Product Bulletin # TM-029 v 1.0

# TM120 v1.3 Upgrade Available

Canrig has issued a kit to upgrade the Canrig® Torq-Matic™ Automated Wrench from version 1.2 to version 1.3. This upgrade includes several improvements on performance and reliability. See below for a summary of new features. Contact your Account Representative or RIGLINE 24/7™ to order this kit.

## 1.4. Side Arm Stopping Plate

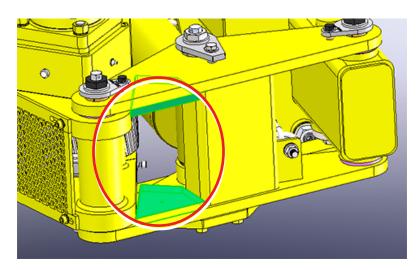
• Added a mechanical stop to prevent the spinner roller frame from colliding with hydraulic cylinder.

## 8. Cylinders

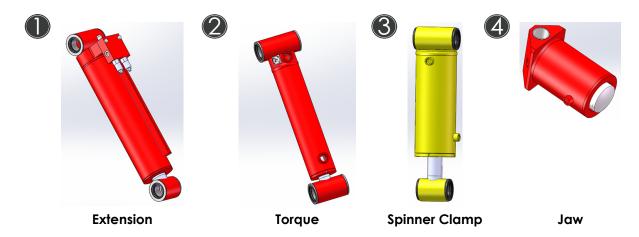
- Integrated internal LVDT and counter-balance valve into extension cylinder (1).
- Integrated internal LVDT for torque cylinder (1 & 2).
- Added greaseless polygon bushings w/wiper seals (all cylinders).
- Improved reliability (all cylinders).
